NEA/RWM/PEER(2012)2

NUCLEAR ENERGY AGENCY
RADIOACTIVE WASTE MANAGEMENT COMMITTEE

THE POST-CLOSURE RADIOLOGICAL SAFETY CASE FOR A SPENT FUEL REPOSITORY IN SWEDEN

An international peer review of the SKB license-application study of March 2011 (Final report)

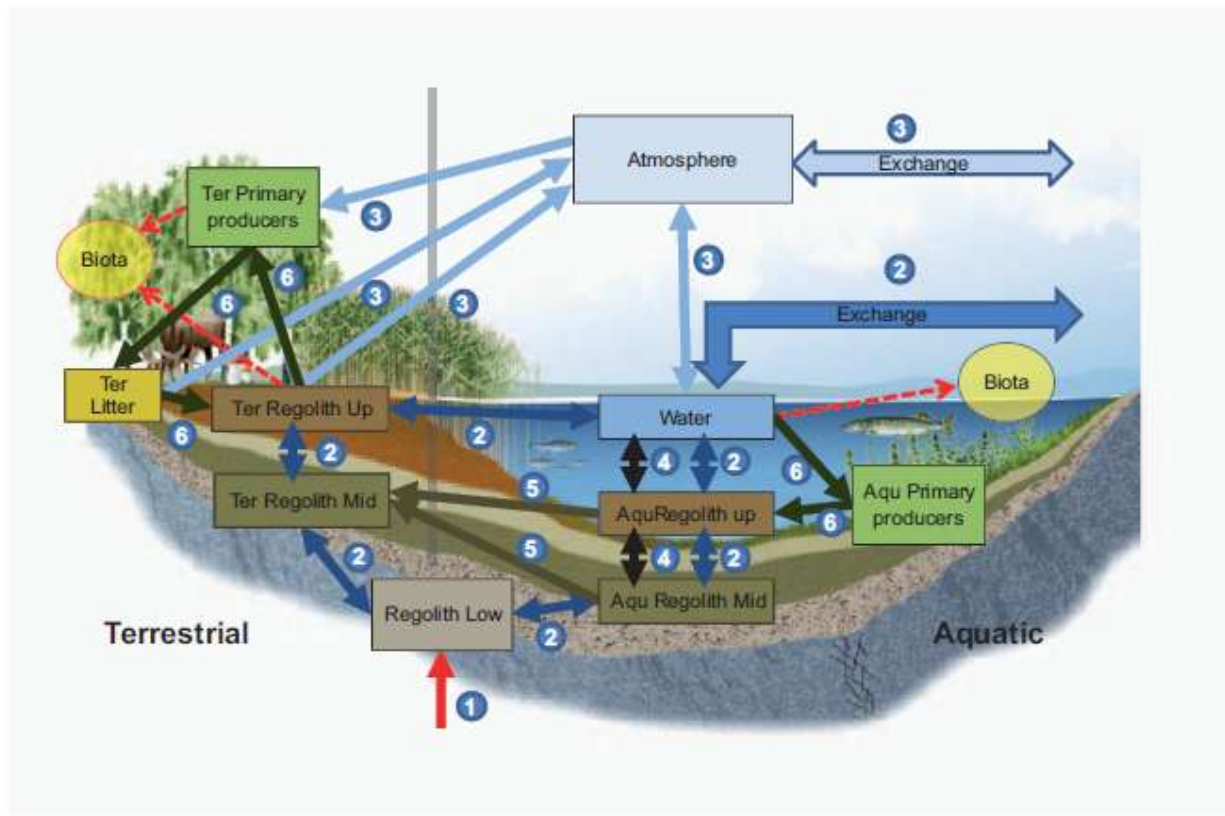
The radionuclide model for the biosphere is a compartment model, where system components that are considered internally homogeneous in their properties are represented by distinct compartments. This is standard practice. The compartment model SKB uses is illustrated in Figure 13-6 in TR-11-01, and is reproduced below. This figure clearly illustrates the various compartments and their connections. The IRT finds SKB's compartments and connections between compartments appropriate.

SKB's assessment of the dose is based on a strong international cooperation in Biosphere assessments. The biosphere analysis for the safety assessment of SR-Site relies upon the application of the IAEA BIOMASS methodology. The exposure of the most exposed group was calculated for a constant release rate of radionuclides to the biosphere, and for a pulse release. Environmental activity concentrations were used to assess the radiological impact on the environment. Only one group is explored (considered as the most exposed group): a family farming wetlands. The justification for this group is its complete self-sufficiency with respect to food and drinking water supply. However, the IRT is of the opinion that some points would benefit from a more precise justification:

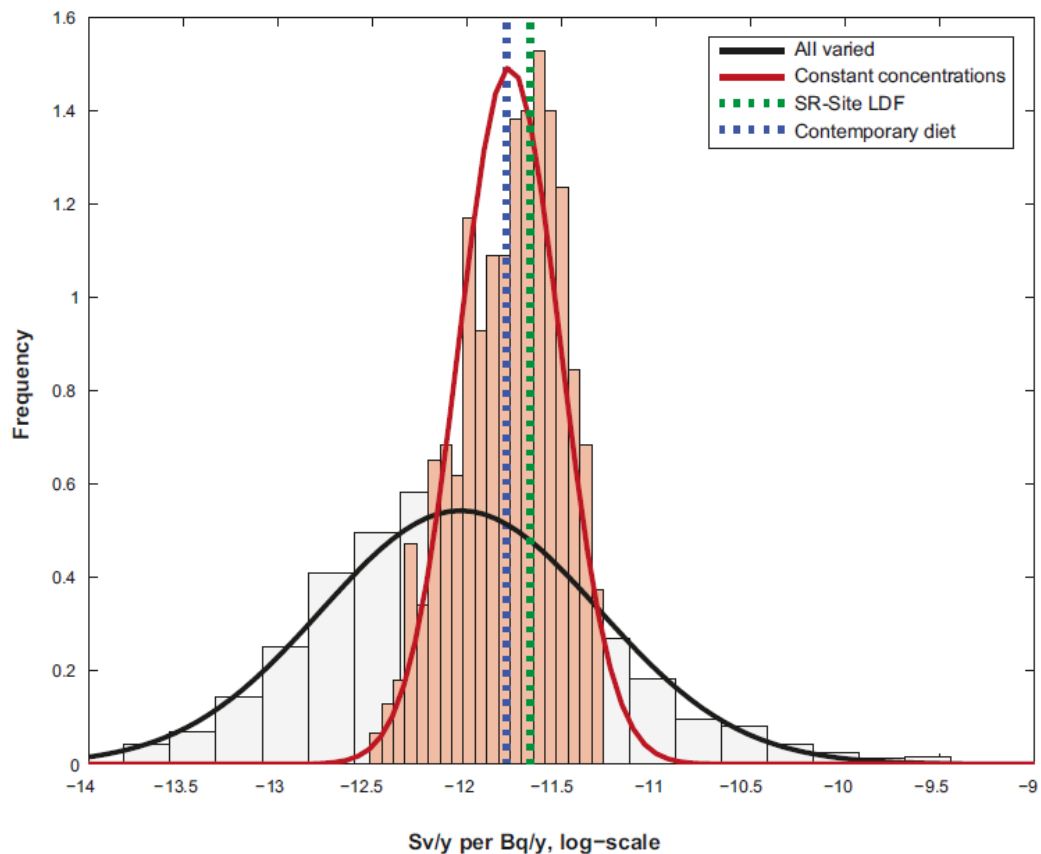
give a reliable estimate of the natural variation. Instead, SKB estimated the Kd value for Ra-226 from literature data spanning a wide range of geographical conditions and soils types. These seem like reasonable conclusions and approaches.

However, SKB notes that use of literature data “clearly exaggerate the uncertainty of Ra-226 retention at the site”. Thus, SKB decided to use the uncertainty in the Ra-226 Kd estimated from the site data in the probabilistic simulations that addressed the effect of parameter uncertainty. The resulting LDF uncertainty spans several orders of magnitude as shown in the figure below (Figure 12-3 reproduced from TR-10-09). Given the importance of Ra-226 in the SKB assessment, and the lack of site-specific data for Kd values for Ra-226, the IRT encourages SKB to attempt to provide better site-specific data for future assessments if at all possible. SKB should also consider that such a large uncertainty in the Ra-226 LDFs could mean that better data would result in some other radionuclide or radionuclides dominating the overall dose rate to the most exposed group. This further underscores the usefulness of obtaining additional, site-specific data for Ra-226.

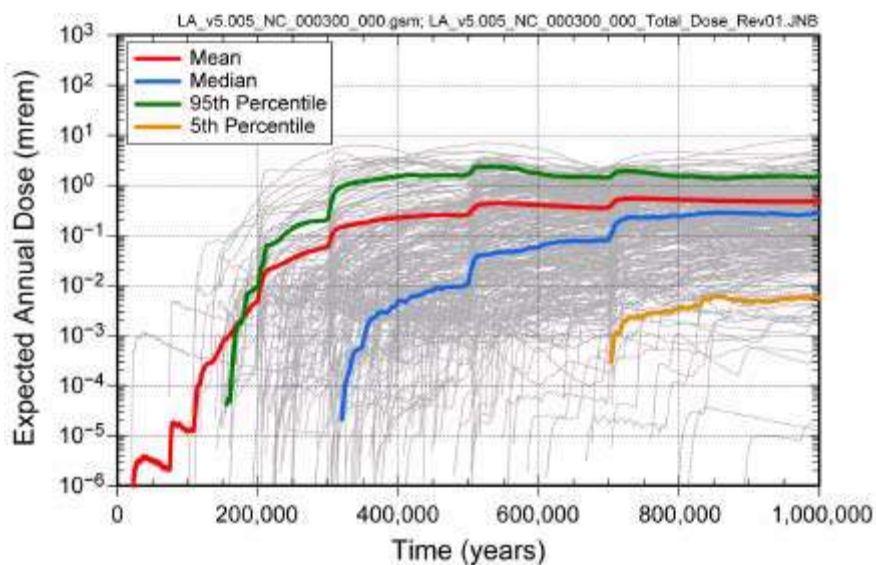
The evaluation of scenarios allows for the calculation of a dose and risk summation, and the conclusions whether the regulatory risk criterion is fulfilled. The risk dilution issue is addressed in a rigorous manner (TR-11-01, chapter 13.9.4): SKB explicitly considers the case of short term releases and calculates an "accumulated short-term risk", following the method suggested in Appendix 1 to SSMFS 2008:37. The result is below the risk limit.

Although the dose calculation based on the technical conclusions drawn from scenarios analyses is sound, the IRT submits the following comment on the presentation of the result: The risk summation curve presents pulse-like features and this is actually an artefact due to the small number of realisations leading to canister failure. Although this does not have any consequence for the demonstration of risk compliance, it is a weakness with respect to the clarity of the demonstration for two reasons:
